**AGENDA
PLAN COMMISSION
MONDAY, OCTOBER 5, 2026
4:30 P.M.
JEFFERSON CITY HALL
MEETING ROOMS**

CERTIFIED SURVEY MAP AND ZONING MAP AMENDMENT REVIEW REPORT TO THE PLAN COMMISSION

Jefferson Planner Comments 9.11.26

SITE PLAN REVIEW REPORT TO THE PLAN COMMISSION

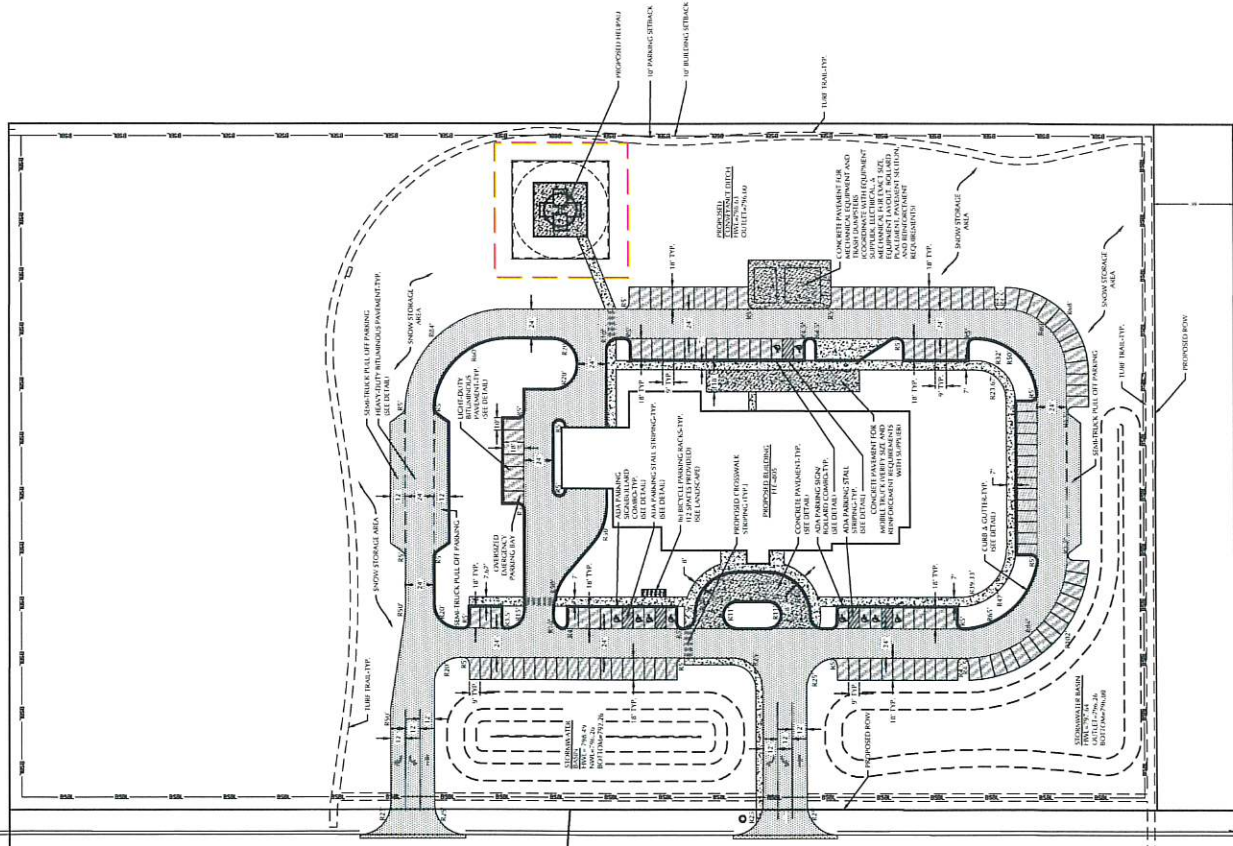
The maximum permitted driveway width is 24 feet. The two proposed driveways are each shown at approximately 36 feet in width and therefore do not comply with the maximum driveway-width requirement. Please revise the site plan to comply with the 24-foot maximum or provide information and justification for any requested modification or exception. To note, the only way the City can waive this requirement is due to the need for fire/public safety access.

It appears that only curbing is proposed around the interior side of the parking lot, but it should be included around the entire parking lot area. Please revise and add curbing around all parking areas and landscaped islands.

Please provide off-street bicycle parking in accordance with applicable zoning requirements. The revised site plan should identify the location, number, and type of proposed bicycle parking spaces. To note, 12 bicycle parking spaces are required and could be 6 inverted U-shaped racks to accommodate 12 total bicycles.

A chain-link fencing detail is included in the submitted plans; however, the location of the proposed chain-link fencing cannot be identified on the site plan. Please clearly identify all proposed chain-link fencing on the site plan. What is surrounding the helipad (thick dashed line)? Is that the fence?

No designated snow-storage areas are identified on the site plan. Given the proposed site configuration, please provide a snow-storage plan identifying where snow will be placed following plowing operations.

Section 300-6.06(N)(5)(a) allows alternatives to the installation of curbing for stormwater management facilities. Curbing was not included around the perimeter of the parking lot as it allows uniform sheet flow out of the parking lot into adjacent stormwater management facilities. Pretreatment is provided by the vegetated area between the parking lot and stormwater management basins. The pretreatment is part of the stormwater management treatment train. It appears that other nearby facilities in the City follow a similar approach by not including perimeter curb and gutter.

12 bicycle parking spaces have been provided as shown on the site plan.

Chain link fencing is no longer needed. No chain link fencing proposed. The dashed lines around the helipad graphically show the safety area and FATO (Final Approach & Take Off Area) as it relates to the flight paths. No fencing is proposed around the helipad.

Snow storage area has been identified on the site plan. There is adequate snow storage around the perimeter of the site.

**SITE PHOTOMETRIC
PLAN**

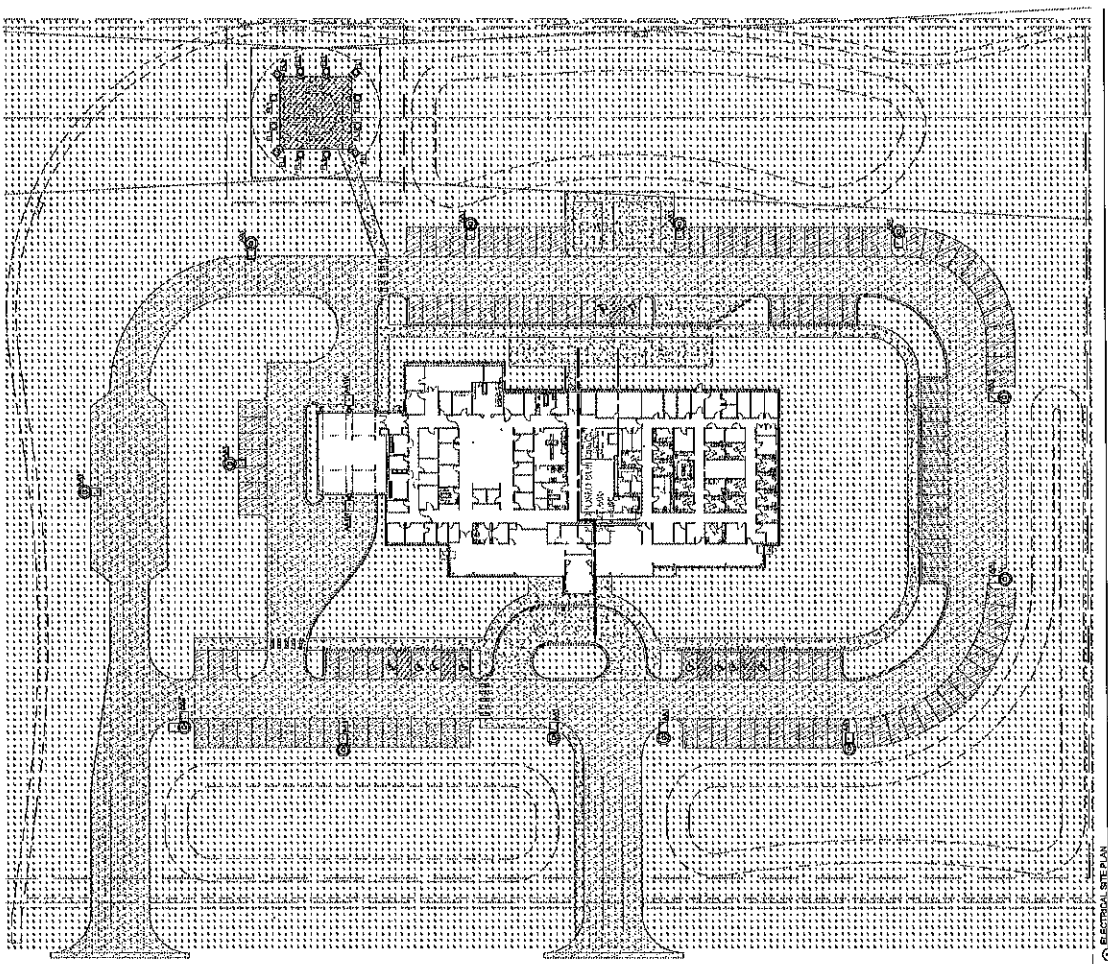
We will need a few additional elements of information from you to be added to the lighting plan. These include:

We will also need you to revise a few items on the lighting plan. These include:

- The maximum height of freestanding light poles in this zoning district is 20 feet. Please reduce the height of those proposed.
- Wall or roof-mounted lighting shall be located at each public entrance with a minimum illumination of 1.0 footcandles, downward facing and fully shielded, and matching the exterior building design. Please add lighting to the front of the building (west side) on the photometrics plan and provide the fixture information/image.

Lighting Engineer will update the site lighting plan to address these comments. Building mounted lighting at man doors will be added to the photometrics. Canopy lighting at front entry will also be included. We will comply by these requirements and recommended
